ARF-023657

SUBJECT: Savannah River Site's Responses to the Regulatory Comments on the Effectiveness Monitoring Report (EMR) for the P-Area Groundwater (PAGW) Operable Unit (OU) Zero Valent Iron Permeable Reactive Barrier (ZVI-PRB) Removal Action (U) March 2019 through March 2021 (SRNS-RP-2021-00016, Revision 0, September 2021) SEMS Number: 81

SCDHEC Comments Received January 6, 2022

USEPA Comments Received January 5, 2022

Figure CR-1.

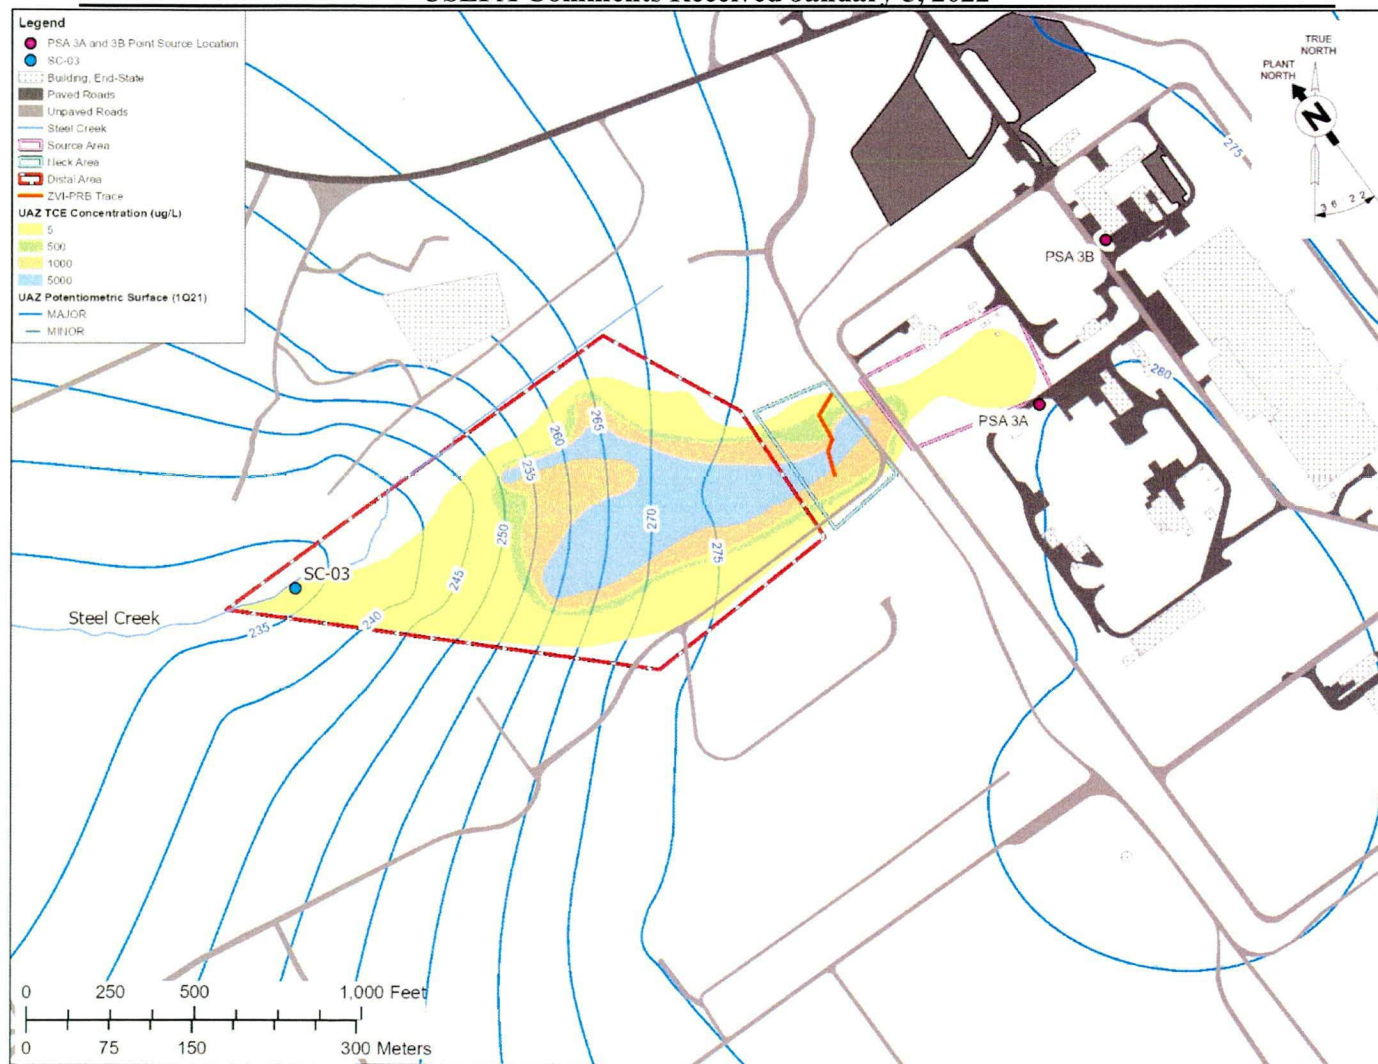
2. **Figure 4. Trichloroethylene Plume Map for the Upper Aquifer Zone of the Upper Three Runs Aquifer (2018 Data), Page 29 of 46, and Figure 5. Trichloroethylene Plume Map for the Lower Aquifer Zone of the Upper Three Runs Aquifer (2018 Data), Page 30 of 46:** Figure 4 and Figure 5 depict three sample location symbols that are not defined in the legend, and it is unclear what type of samples are collected or their significance. Additionally, the ZVI-PRB orientation depicted as a blue line in the neck area of the figure has not been defined in the legends. *Please revise the figures to define the three sample symbols and provide the definition of the ZVI-PRB orientation in the legends.*

Response: Agree with Clarification

The three locations included in both figures are for reference from the text. The location types will be added to the figure legends in future EMRs. Additionally, the ZVI-PRB trace will be identified in the legends on future EMRs.

Revised Figure 4 and Figure 5 are included below as Figure CR-1 and Figure CR-2, respectively.

Figure CR-3. Revised Figure 7 Based on Specific Comment #3 and #4

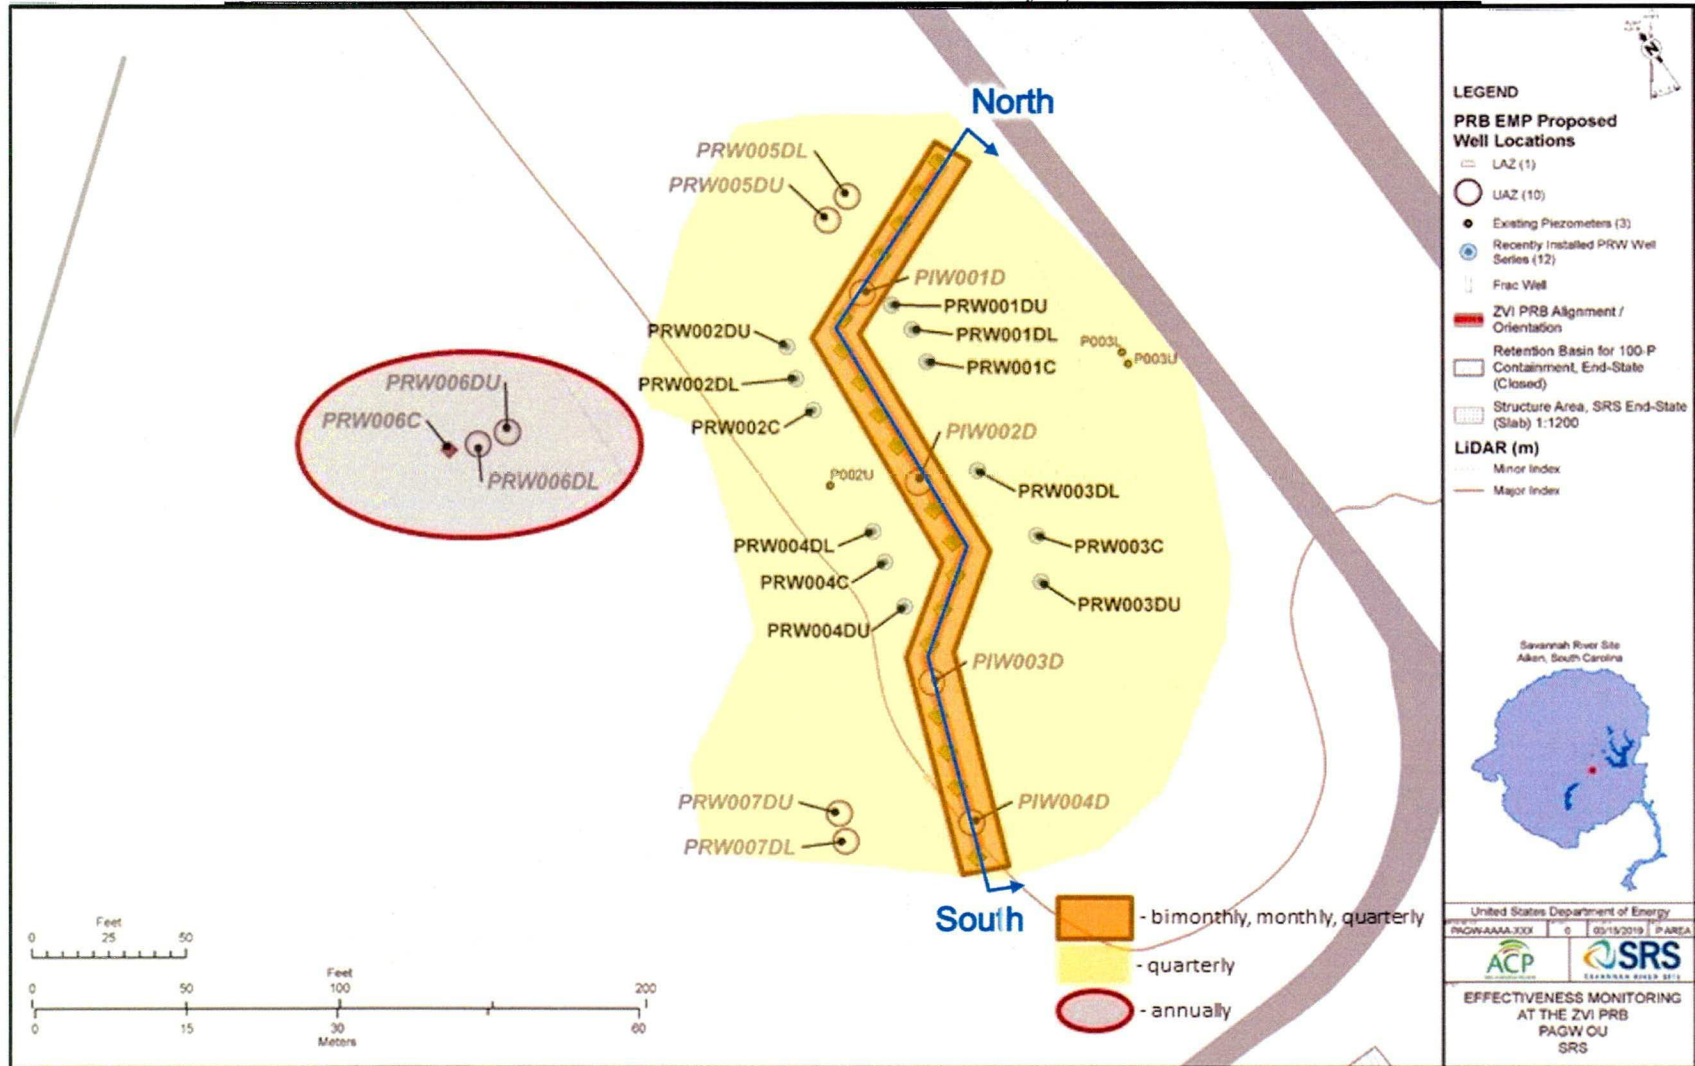
3. **Figure 6. TCE Plume Cross-Section with ZVI-PRB Injection Wells, Page 31 of 46:** The figure does not depict or reference a map showing the plan view of the cross-section line provided on the figure. It is uncertain whether the cross-section line is equivalent to the ZVI PRB orientation line. *Please revise the Report to explain in the text and on a figure the location of the cross-section line presented on Figure 6.*

4. **Figure 7. Effectiveness Monitoring Plan Locations, Page 32 of 46:** The small red box symbol used for PRW006C is not defined in the legend. *Please revise the legend in Figure 7 to include all symbols and definitions.*

Figure 6 is a cross-section of the ZVI-PRB trace. This will be clarified in future EMRs with the revised Figure 7 (included below as Figure CR-3) and the following text revision:

The symbol for PRW006C was intended to be for “LAZ (1)” locations under the PRB EMP Proposed Well Locations heading. This symbol was corrected on the legend in the revised Figure 7 (Figure CR-3 included below) and will be included in future EMRs.
